Dictation Products Service Bulletin

Model: RDI-500/RD-400, RDI-500/RD-500

No. 6

Subject: Telephone Line Disconnection

RD-400, RD-500 AUDIO BOARD, MOUNT SIDE

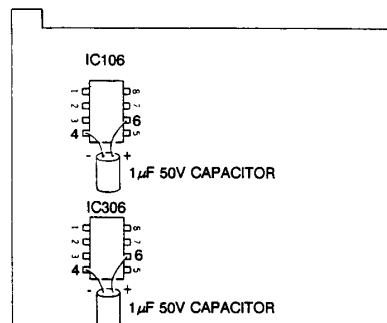
Symptom:
(22)

Intermittently RDI-500 disconnects the telephone line right after the connection is made.

On RD-400 and RD-500 Audio Board, install 1 μ F 50V capacitor, 1-126-301-11, at IC106 and IC306 pin 6 for + and pin 4 for -.
